UNITED STATES PATENT AND TRADEMARK OFFICE

10/576,398

| Office Action Summary | Application No. 10/576,398 | Applicant(s) GERMAIN, JEAN-PIERRE | |

DETAILED ACTION

Lozhkin et al. Figure: Filter for cryogenic liquids.

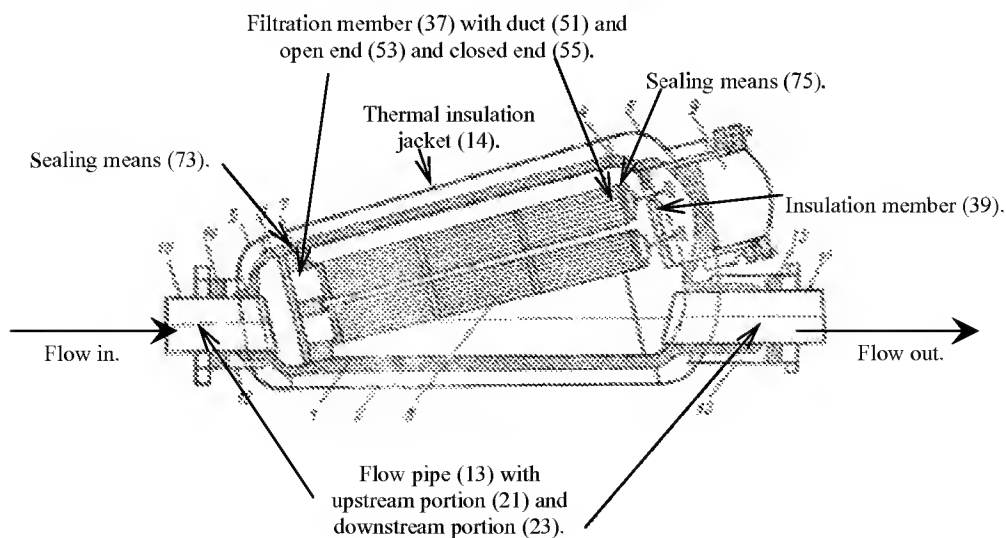
3. Claims 10 and 11-13 are rejected under 35 U.S.C. 102(b) as being anticipated by Lozhkin et al. (SU403926, Dec. 3, 1974 – The EPO abstract from the esp@cenet database, the Derwent abstract, the patent, and an English translation).
4. Regarding claim 10, Lozhkin et al. discloses “filters for cryogenic liquids.” Lozhkin et al., Translation, page 2, lines 2-3. The Lozhkin et al. installation is shown below, with the flow pipe (13) having a filtration member (37) and an insulation jacket (14).

5. Lozhkin et al. discloses a reversal of the flow through the apparatus relative to that of the invention. The recited "upstream" and "downstream" limitations of claim 10 do not distinguish the invention from Lozhkin et al. because apparatus claims must be structurally distinguishable from the prior art in order to be patentable. As is stated at MPEP 2114, " While features of an apparatus may be recited either structurally or functionally, claims directed to an apparatus must be distinguished from the prior art in terms of structure rather than function. *In re Schreiber*, 128 F.3d 1473, 1477-78, 44 USPQ2d 1429, 1431-32 (Fed. Cir. 1997) (The absence of a disclosure in a prior art reference relating to function did not defeat the Board's finding of anticipation of claimed apparatus because the limitations at issue were found to be inherent in the prior art reference)." As will be shown below in the instant case, the invention is not structurally distinguishable from the Lozhkin et al. installation.

6. In the above figure, Lozhkin et al. discloses that the filtration member (37) has a duct (51) through its center with an upstream open end (53) and a downstream closed end (55) with the duct being partially defined by the porous wall of filtration member (37). The duct (51) is known to exist from Lozhkin et al.'s description of the flow through the apparatus. Lozhkin et al. discloses "The flow medium enters via connection 11 into insert 8, in which it is filtered and then discharged from the filter through connection 10." Lozhkin et al., p. 3, lines 4-5. The filtration member also has a sealing means (73) at its lower end and a sealing means (75) at its upper end, as recited.

7. In the above figure, Lozhkin et al. further teaches that the flow pipe (13) has a double-walled thermal insulation jacket (14), with filtration members (37) secured inside. The flow pipe's upstream portion (21) emerges into the upstream open-end (53) of duct (51) through

sealing means (73). The flow pipe's downstream portion (23) emerges opposite the porous wall of filtration member (37).

8. In the above figure, the Lozhkin et al. also discloses that the flow pipe (13) has a branch extending parallel to the flow axis between upstream portion (21) and a free end. The branch contains two filtration members (37). The branch also contains insulation member (39) which is mounted to bear on the closed end (55) two filtration members (37) and the free end of the branch. Sealing means (75) are located between the filtration member (37) and the insulation member (39) and the sealing means (75) is maintained in compression.

10. Lozhkin et al. also anticipates claims 11-13, as shown in the above figure. The Lozhkin et al. sealing means (73) is maintained in compression by the filtration members (37) and the upstream portion 21 [claim 11]. The Lozhkin et al. upstream portion (21) is adjacent to the open end (53) leading in to the filtration members (37) [claim 12]. The angle between the branch portion and the flow axis is between about 10 and 30 degrees [claim 13].

Lozhkin et al. Figure: Filter for cryogenic liquids.

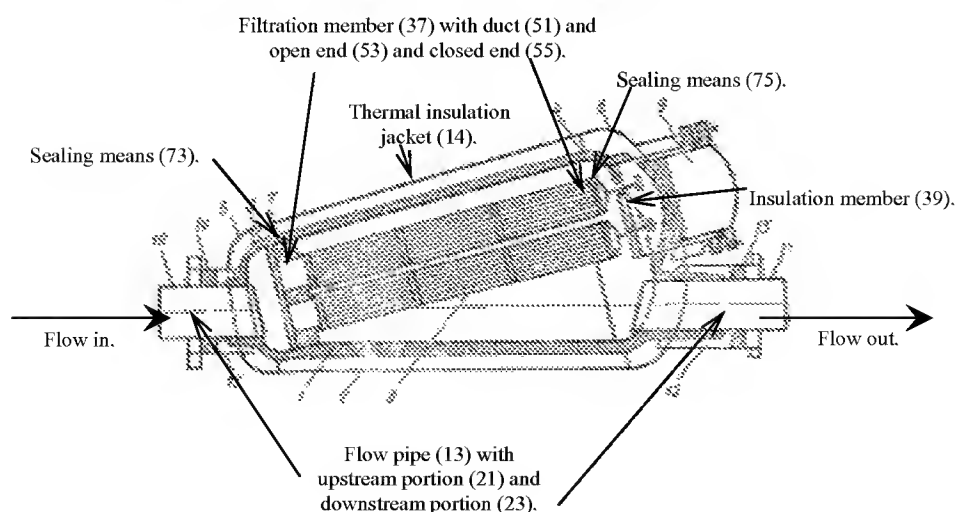
- a. Regarding claim 10, applicant argues, "Lozhkin fails to disclose, teach. or suggest all the limitations of the claims, including:
- a) a filtration member having a porous wall;
 - b) a duct formed in the filtration member and being at least partially defined by the porous wall;
 - c) the duct has an open upstream end;
 - d) the emergence of an upstream portion (21) of a liquid flow pipe (13) into an open end (53) of a duct (51) . . . via interposed sealing means 73; and
 - e) emergence of a downstream portion (23) of the liquid flow pipe (13) opposite a lateral region (59) of the porous wall (57) extending in the flow axis (Y-Y') along which the duct extends." Applicant's Remarks, p. 5, lines 9-21.

- b. Regarding claim 10, applicant argues that the claimed invention is distinguished over the prior art because “the cryogenic media purification filter of Lozhkin actually operates in a fashion opposite to that of the instant application” and “[t]hus, in the Lozhkin connection 10 does not emerge opposite a lateral region of a wall extending in a flow axis along which the duct extends” as recited. Applicant’s Remarks, p. 5, lines 25-26; p. 6, lines 3-4.

From the above figure, Lozhkin et al. discloses:

- a) a filtration member (37) having a porous wall;
 - b) the filtration member (37) has a duct (51) through its center with the duct (51) being partially defined by the porous wall of filtration member (37).

- c) the duct (51) has an open upstream end (53);
 - d) the emergence of an upstream portion (21) of a liquid flow pipe (13) into an open end (53) of a duct (51) . . . via interposed sealing means (73); and

- e) emergence of a downstream portion (23) of the liquid flow pipe (13) opposite a lateral region of the porous wall of the filtration member (37) extending in the flow axis along which the duct (51) extends.

The examiner responds as in the above patentability analysis. Lozhkin et al. discloses a reversal of the flow through the apparatus relative to that of the invention. The recited "upstream" and "downstream" limitations of claim 10 do not distinguish the invention from Lozhkin et al. because apparatus claims must be structurally distinguishable from the prior art. As MPEP 2114 states, "While features of an
